PORT OF BROOKINGS HARBOR
Special Commission Meeting
Thursday, February 4, 2021 • 9:00am
Teleconference / Meeting Room *(limited capacity)*

ACTION ITEM – A

DATE: February 4, 2021
RE: Fuel Dock Project Changes
TO: Honorable Board President and Harbor District Board Members
ISSUED BY: Gary Dehlinger, Port Manager

From: Jack <emc@emcengineersscientists.com>
Sent: Wednesday, February 3, 2021 8:41 AM
To: Gary Dehlinger-Port of Brookings Harbor
Subject: Fuel Dock Access Pad

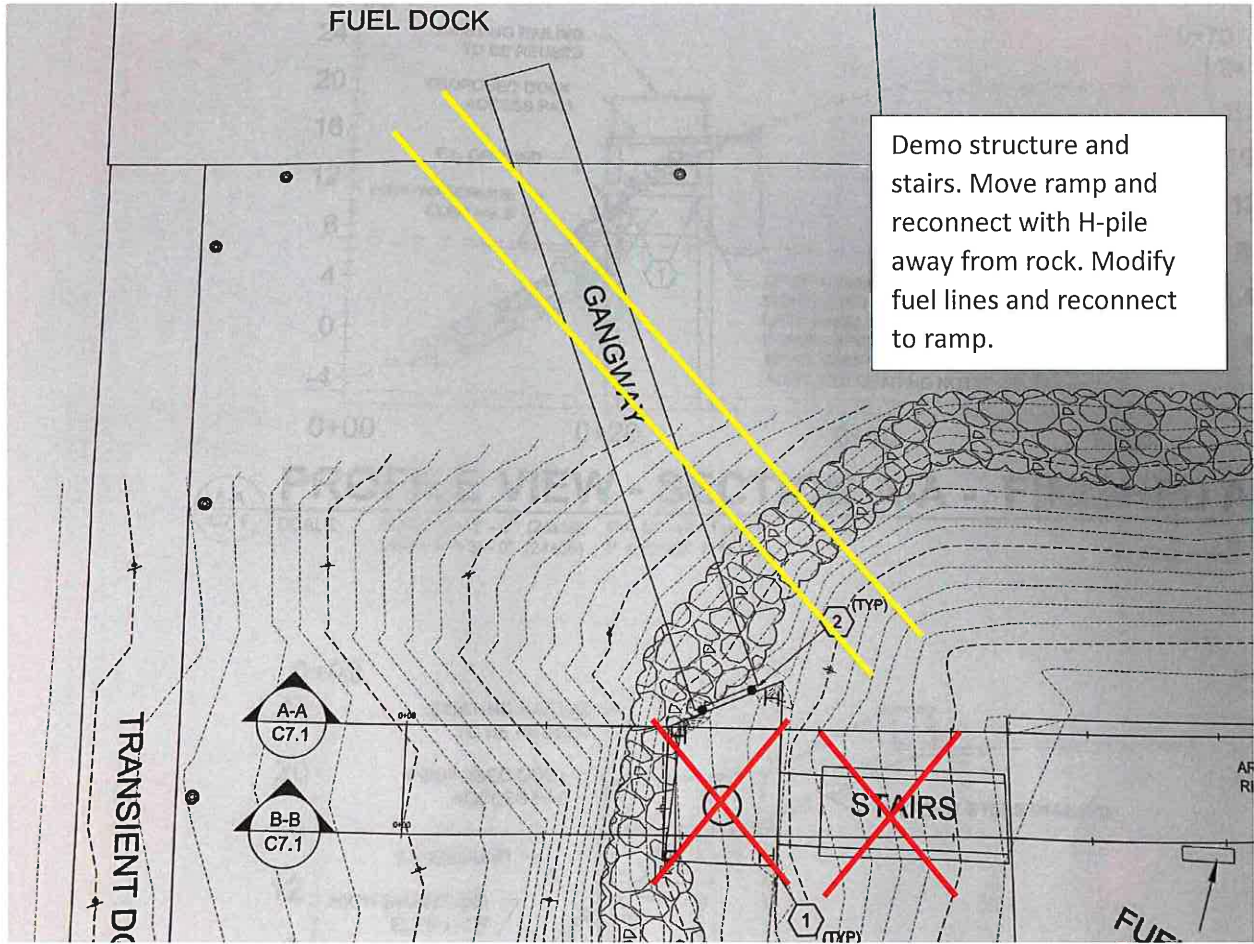
Slope Difference

An estimated increase/decrease in gangway slope can be estimated. The top concrete pad (above the steps) is fixed to about +22' MLLW elevation. The top of the fuel dock access pad (now removed) was at about +16' MLLW. Given a lowest low tide of -2' MLLW, and adding 2 feet to top of Fuel dock decking, we have a maximum drop from the pad of 16'. The length along the top of 50' gangway from the north edge of access pad to the edge of the fuel dock is about 44.5'. Therefore the maximum gangway slope in % is about 38.4% (approx.. 21 degrees). If a 60' gangway was used without a pad, it looks like we can place on-shore connection

to H-piles at about +20' MLLW elevation. The resulting elevation difference would be 20 feet, and the resulting slope about 37.4%.

So, given the placement as described, there would be no significant change in slope by eliminating the fuel dock access pad.

It was suggested during the above-described discussions that a 60' gangway, presently planned for the work dock access, could be exchanged with the present fuel dock access pad 50' gangway.
